# 3010 APARTMENTS

3010 & 3014 SW AVALON WAY, SEATTLE, WA

SDCI Project #3035979-LU  
Recommendation Meeting  
Southwest Design Review Board

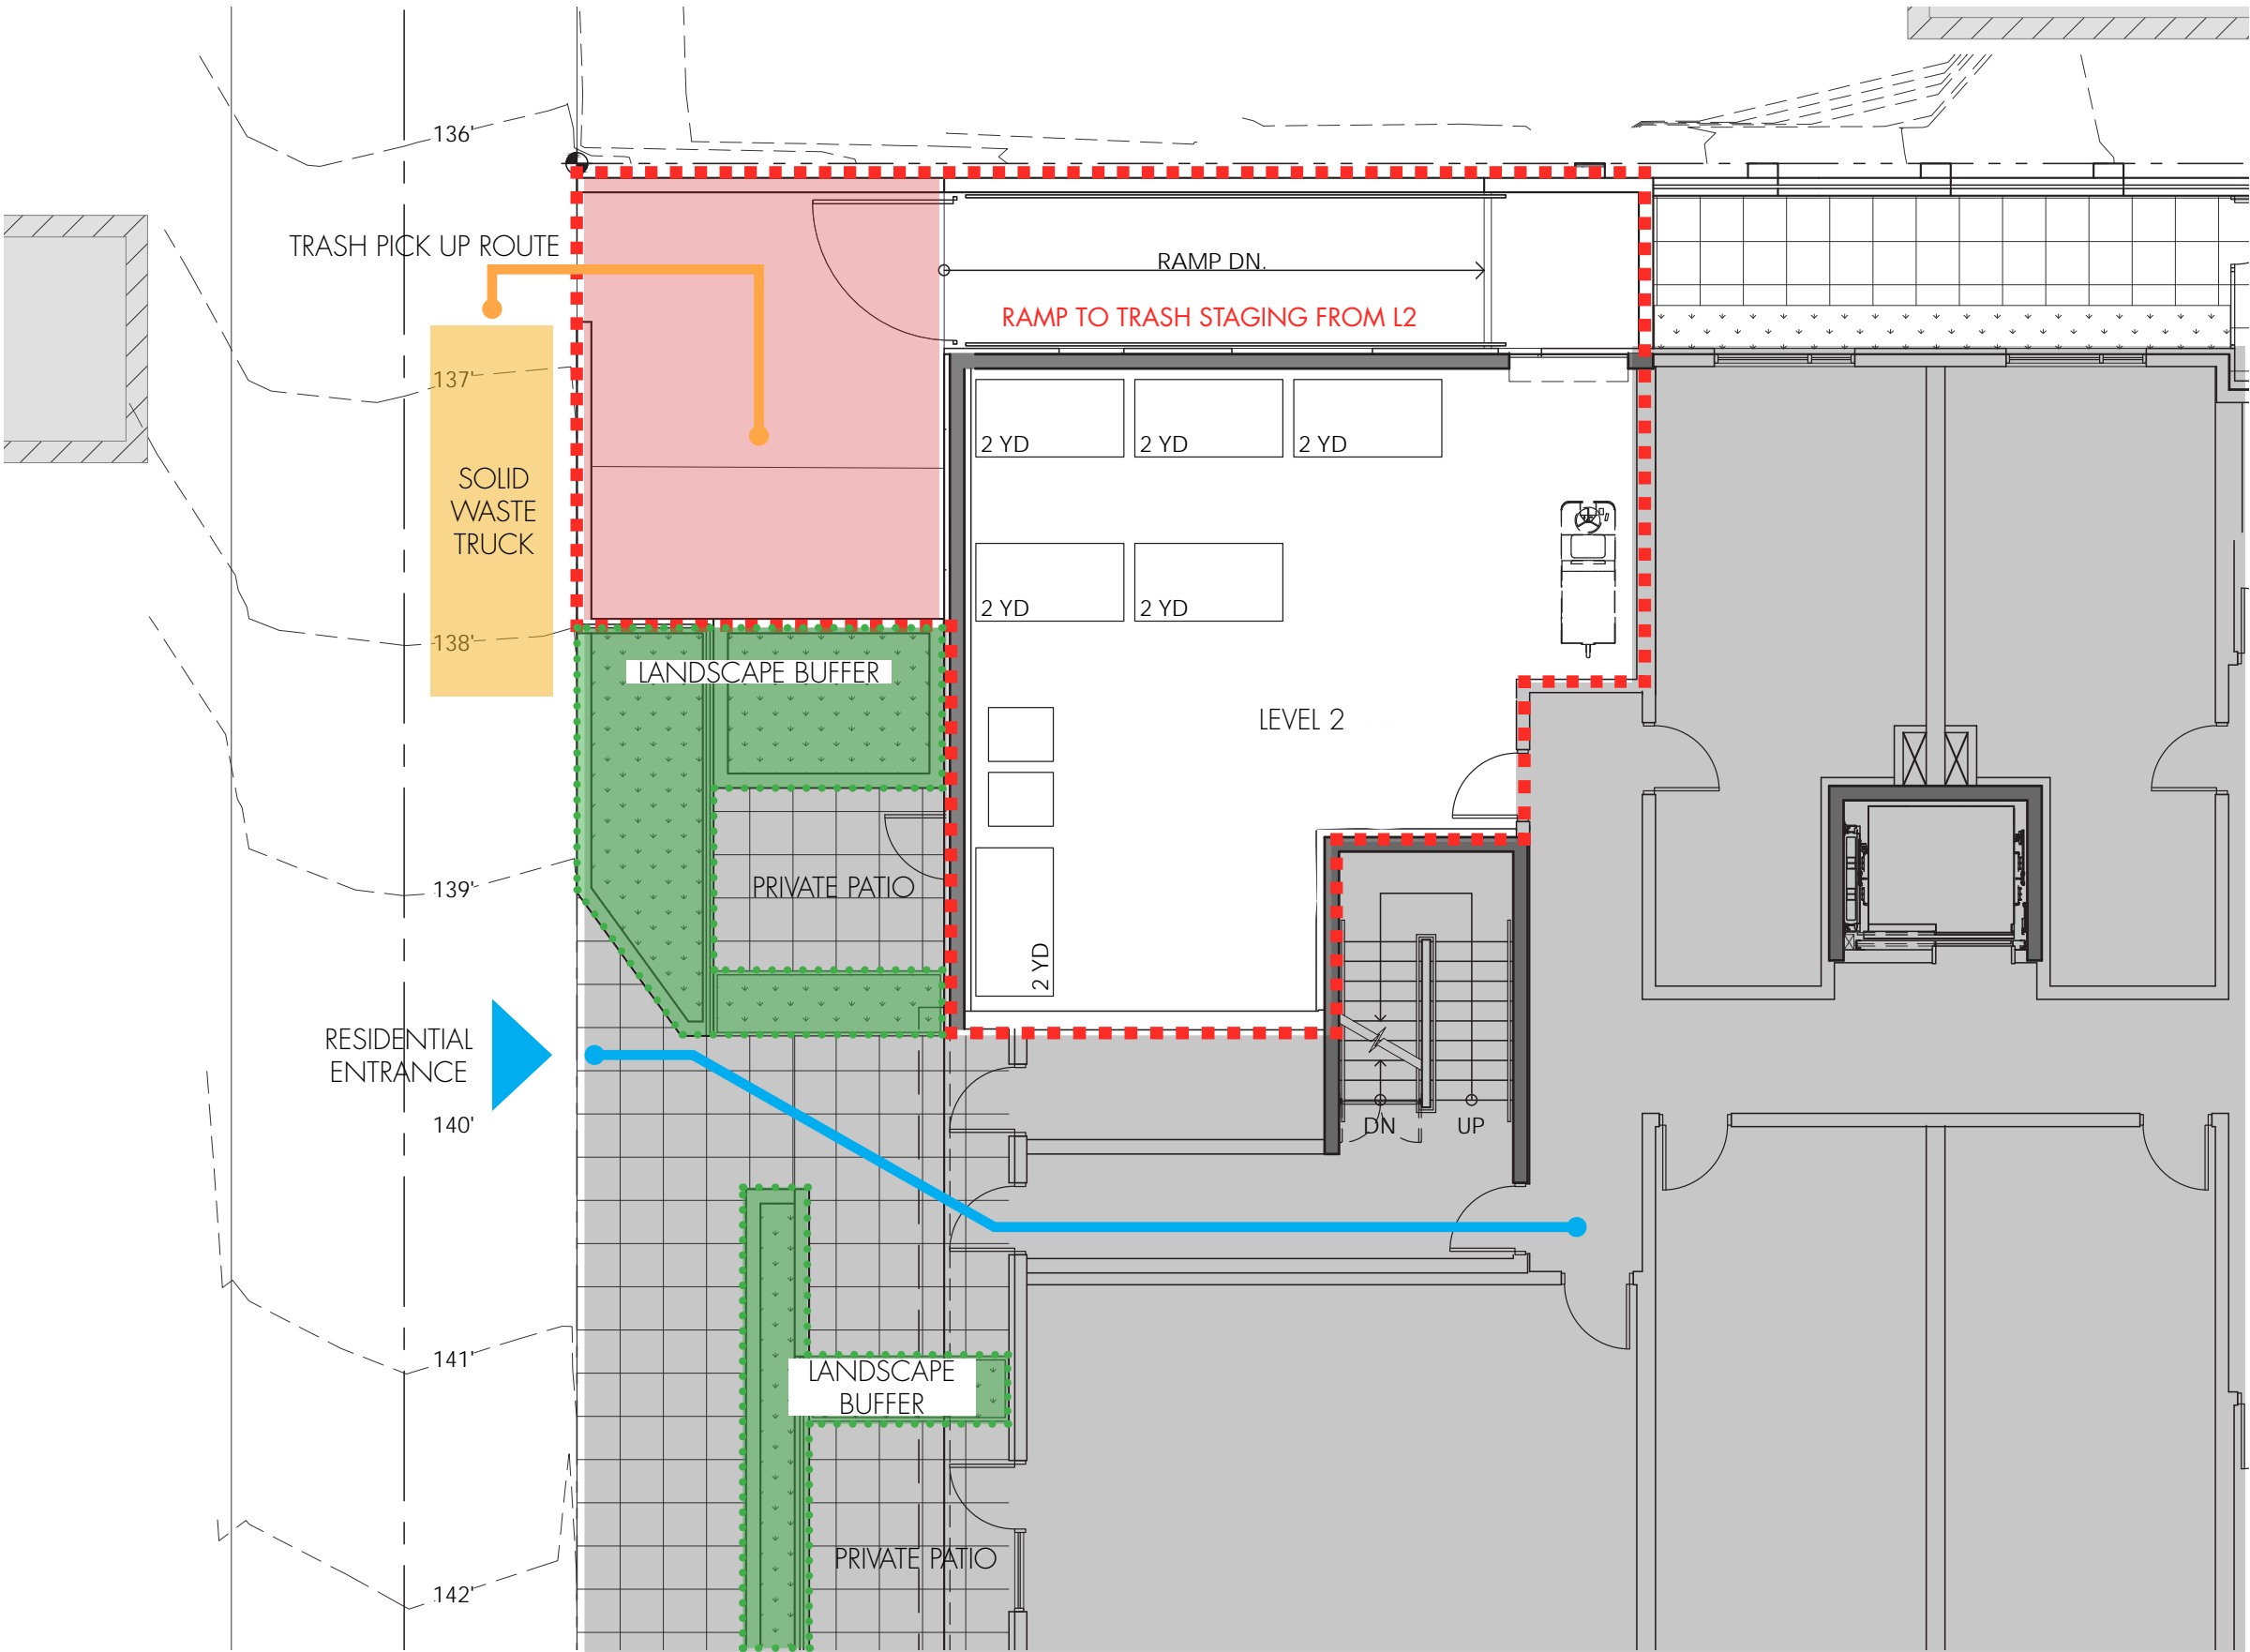
b. The Board acknowledged the issues of access to the rear of the building from the steep alley. They noted, however, that the applicant should consider public concerns regarding traffic and congestion in the alley as they related to the design of that area. The Board gave guidance to integrate parking, services and access into the site design and to coordinate the grading with interior building levels. (DC1-B-1, DC1-C-4, and CS1-C)

The parking stalls have been removed from the project and a courtyard has been designed along the alley. The courtyard is designed with seating, landscaping and a covered area along the building façade. These design changes should help to alleviate traffic and congestion in the alley.
